### **Addendum 9: United Nations Global Technical Regulation No. 9**

**United Nations Global Technical Regulation on Pedestrian Safety**

#### **Amendment 2**

Established in the Global Registry on 14 November 2018

Figure 28

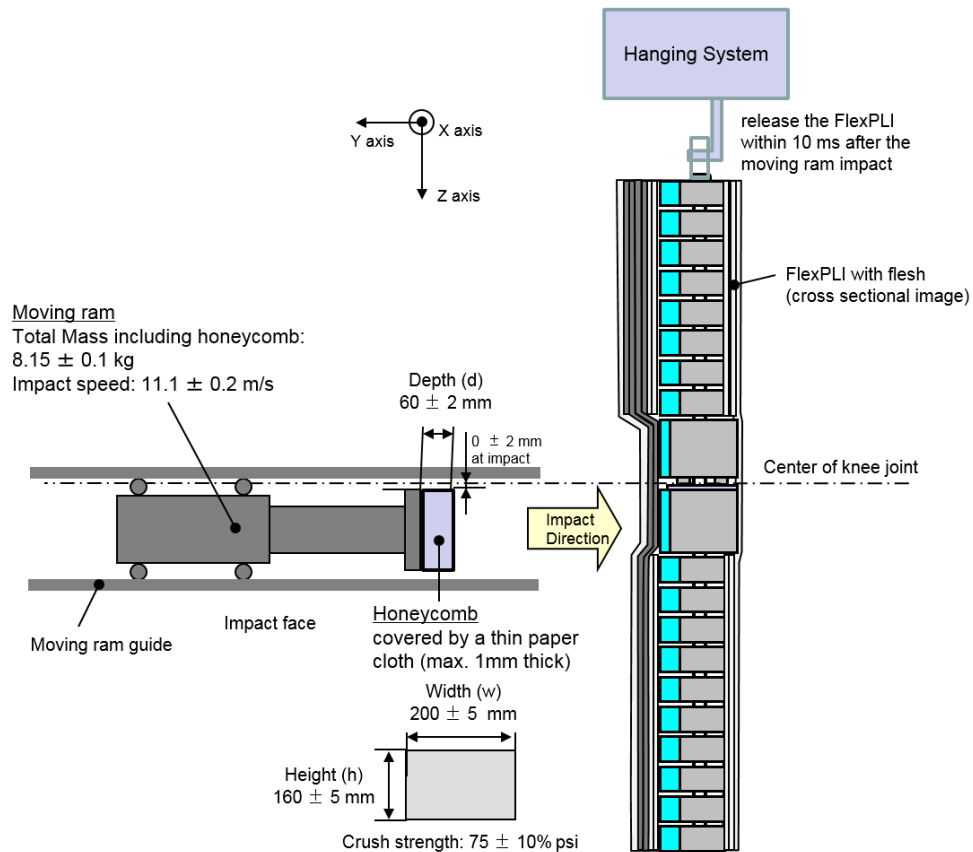
- 8.1.3.4. Test procedure
  - 8.1.3.4.1. The assembled flexible lower legform impactor (with the flesh and skin) shall be hung vertically and freely suspended from a test rig as shown in Figure 28. It is then impacted by the upper edge of a linearly guided aluminium honeycomb impactor, covered by a thin paper cloth with a maximum thickness of 1 mm, at an impact speed of  $11.1 \pm 0.2$  m/s. The legform shall achieve a free flight condition within 10 ms after the time of first contact of the honeycomb impactor.

- 8.1.3.4.4. At the time of the first contact, the flexible lower legform impactor pitch angle (rotation around the Y-axis) and, therefore, the pitch angle of the velocity vector of the honeycomb impactor shall be within a tolerance of  $\pm 2^\circ$  in relation to the lateral vertical plane. The flexible lower legform impactor roll angle (rotation around the X-axis) and, therefore, the roll angle of the honeycomb impactor shall be within a tolerance of  $\pm 2^\circ$  in relation to the longitudinal vertical plane. The flexible lower legform impactor yaw angle (rotation around the Z-axis) and, therefore, the yaw angle of the velocity vector of the honeycomb impactor shall be within a tolerance of  $\pm 2^\circ$ .
